OUR
TOWN
HALL
PROJECT

PROJECT STATUS	RIBA STAGE 5		
CLIENT	MANCHESTER CITY COUNCIL		
PROJECT	OUR TOWN HALL		
DRAWING TITLE	GHR05 and GHR06 chute outlet detail		
SIZE & SCALE	[A3] 1 : 5		
DRAWING STATUS	S4 Construction		
JOB NUMBER	236959		
DRAWING NO.	OTH-PUR-TH-RF-DWG-A-7474		REV
	01

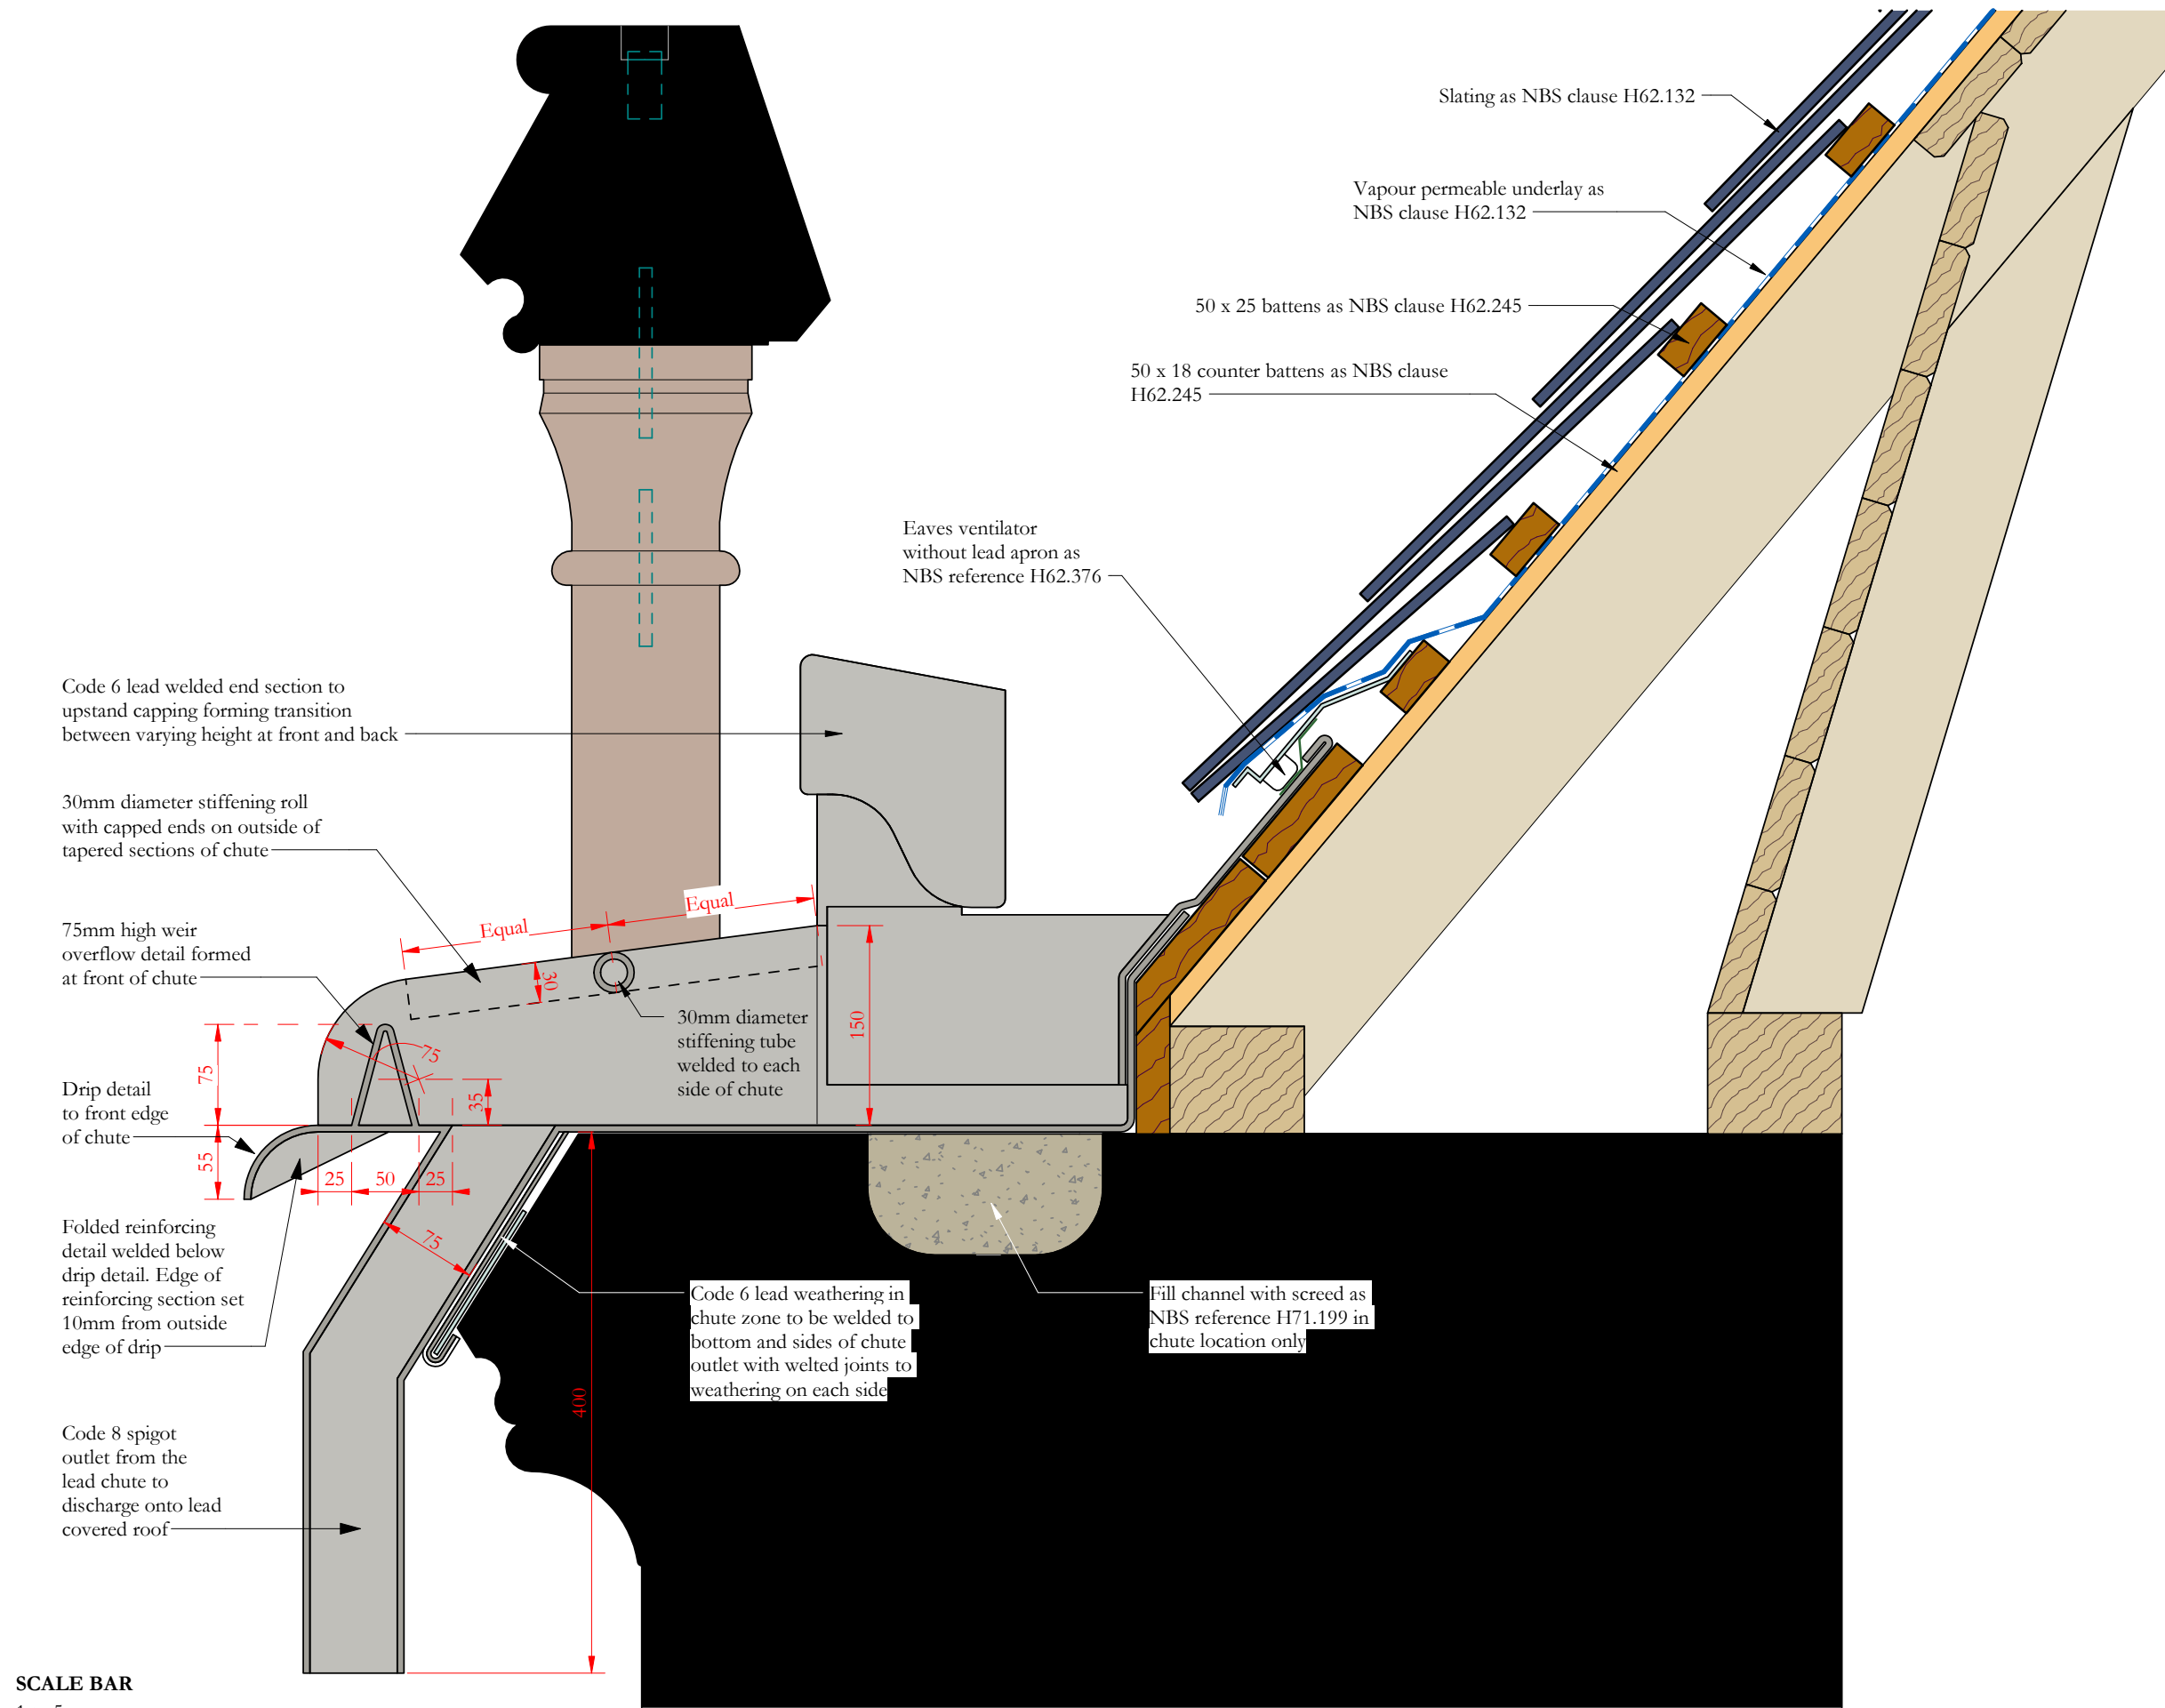
Revision 01: Configuration of board at back of chute changed to continuous slope matching roof pitch to eliminate flat section at bottom of roof slope
